UNITED STATES PATENT AND TRADEMARK OFFICE

| APPLICATION NO. | FILING DATE | FIRST NAMED INVENTOR | ATTORNEY DOCKET NO. | CONFIRMATION NO. |
|-----------------|-------------|----------------------|---------------------|------------------|
| 10/820,134 | 04/08/2004 | Han Jun Sung | 1594.1364 | 6666 |

| Office Action Summary | Application No. | | Applicant(s) | |

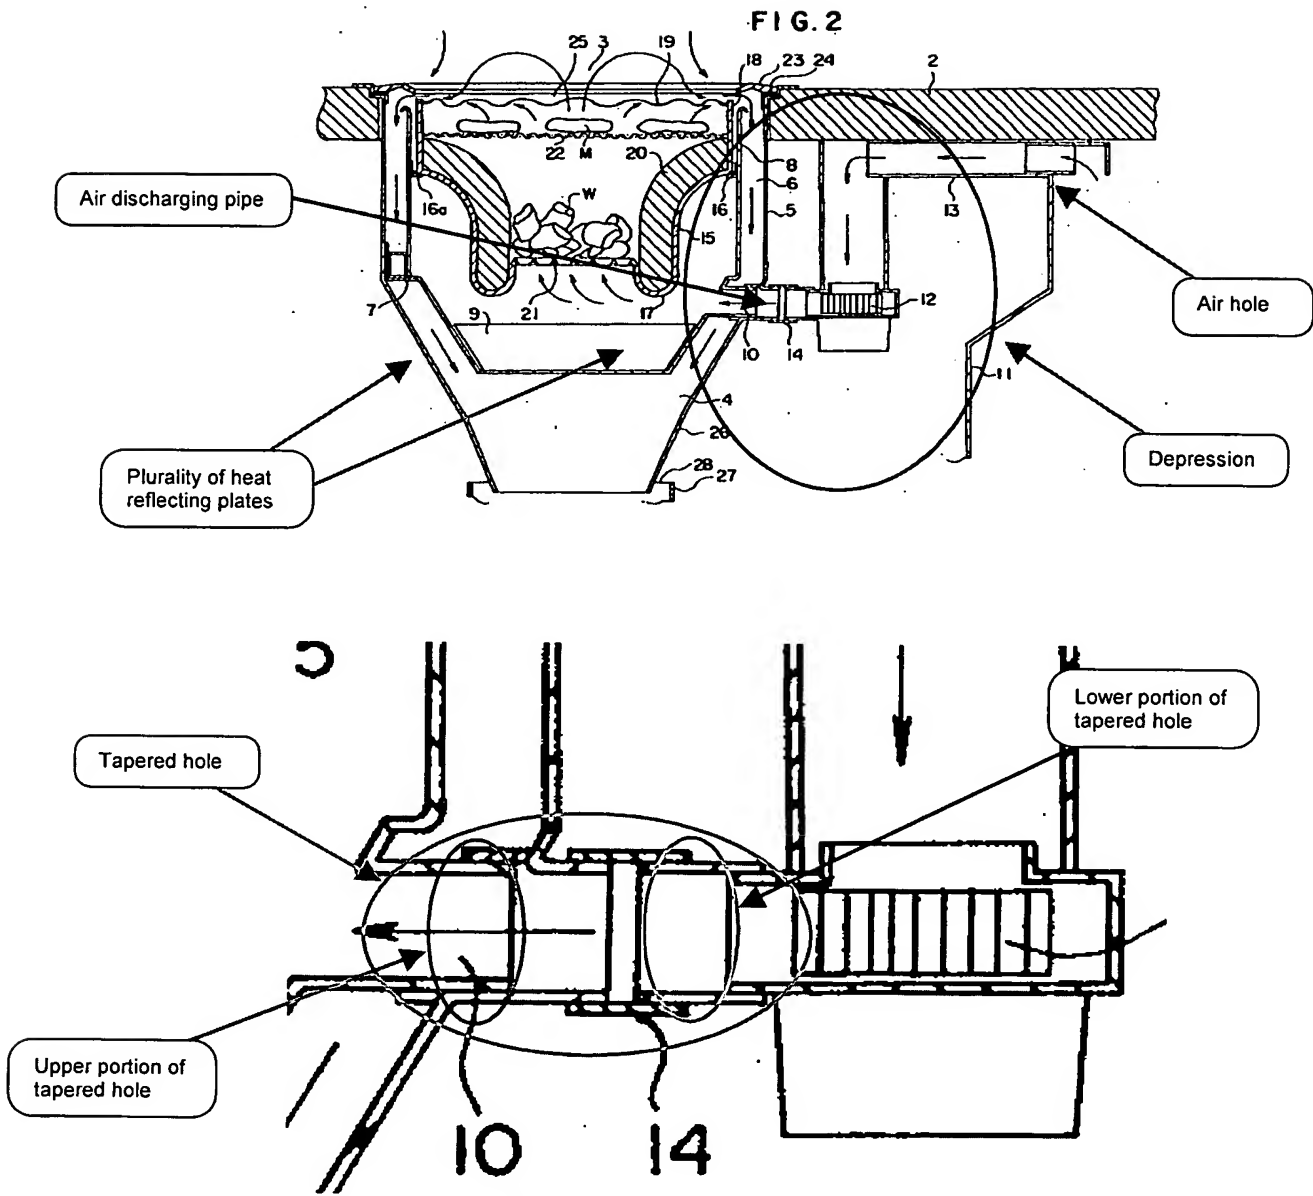
- the grilling pipe has an inlet at one end and an outlet at another end thereof (as seen in Figure 2);
- an air discharging pipe (as seen in the illustration of Figure 2 below) to connect the blowing fan to the inlet of the grilling pipe, the air entering the grilling pipe by the blowing fan blowing air into the air discharging pipe and being discharged to an area outside of the grilling pipe through the outlet of the grilling pipe (as seen in Figure 2);

- the connection member comprises a tapered hole (as seen in the first partial illustration of Figure 2 below) that is tapered in a direction from a top to a bottom of the connection member, the inlet of the grilling pipe being connected to an upper portion of the tapered hole (as seen in the first partial illustration of Figure 2 below), and the air discharging pipe being connected to a lower portion of the tapered hole (as seen in the first partial illustration of Figure 2 below) to allow the grilling pipe to be removably connected to the air discharging pipe using the connection member (inherent);

- a frame (8 – inner box) that is provided on an upper portion of the grilling pipe along an edge of the grilling pipe (as seen in Figure 2);
- the outlet of the grilling pipe is placed at a predetermined position of the frame (as seen in Figure 2);

- a grease collecting unit (9 – dust pan), provided in the cabinet under the grilling unit (as seen in Figure 2);
- the heating unit comprises a plurality of heating units (there is a plurality of charcoal pieces) that are respectively arranged on opposite side surfaces of the cabinet (as seen in Figure 2), and the grease collecting unit comprises a plurality of heat reflecting plates that face the heating units (as seen in the illustration of Figure 2 below);

- the upper portion of the tapered hole has a diameter greater than an outer diameter of the grilling pipe (as seen in the second partial illustration of Figure 2 below), the lower portion of the tapered hole has a diameter less than the outer diameter of the grilling pipe (as seen in the second partial illustration of Figure 2 below), and the diameter of the lower portion of the tapered hole is approximately equal to an outer diameter of the air discharging pipe (as seen in the second partial illustration of Figure 2 below);

(First partial illustration of Figure 2)

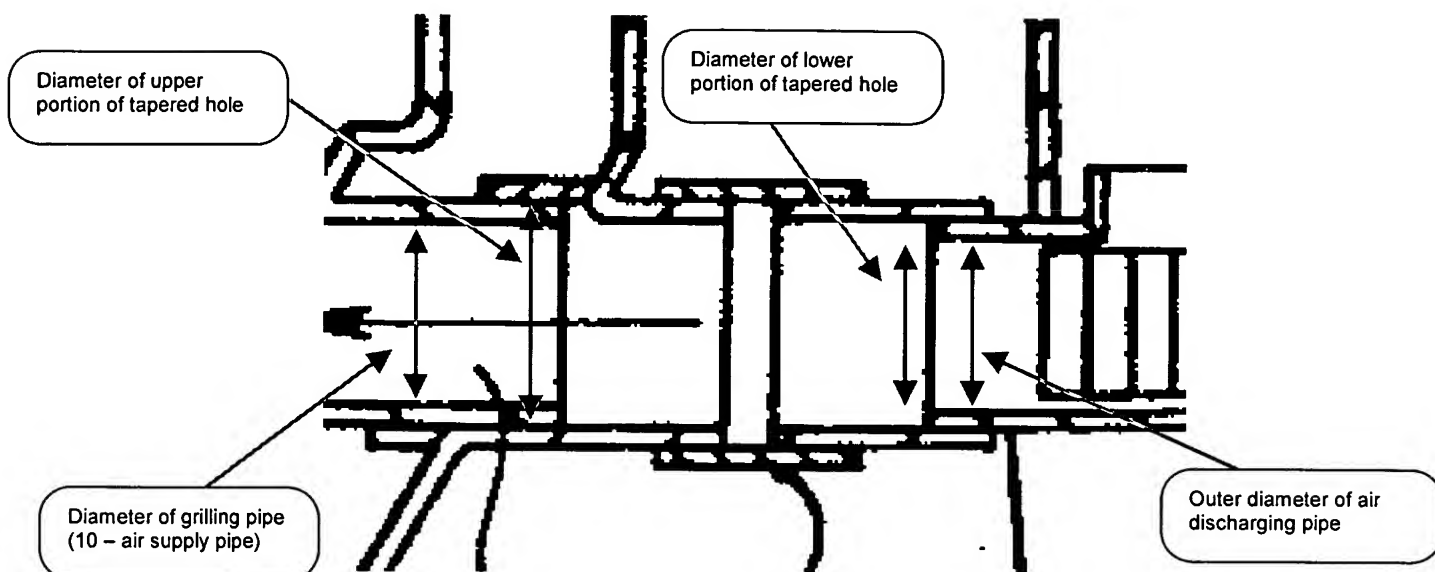
- a connection member (14 – connecting pipe) provided on an upper portion of the cabinet to connect the air discharging pipe to the inlet of the grilling pipe (as seen in Figure 2), the connection member having a tapered hole (as seen in the first partial illustration of Figure 2 above) that is tapered in a direction from a top to a bottom of the connection member, with the inlet of the grilling pipe being connected to an upper portion of the tapered hole (as seen in the first partial illustration of Figure 2 above), and the air discharging pipe being connected to a lower portion of the tapered hole (as seen in the first partial illustration of Figure 2 above) to allow the grilling pipe to be removably connected to the air discharging pipe using the connection member (inherent);
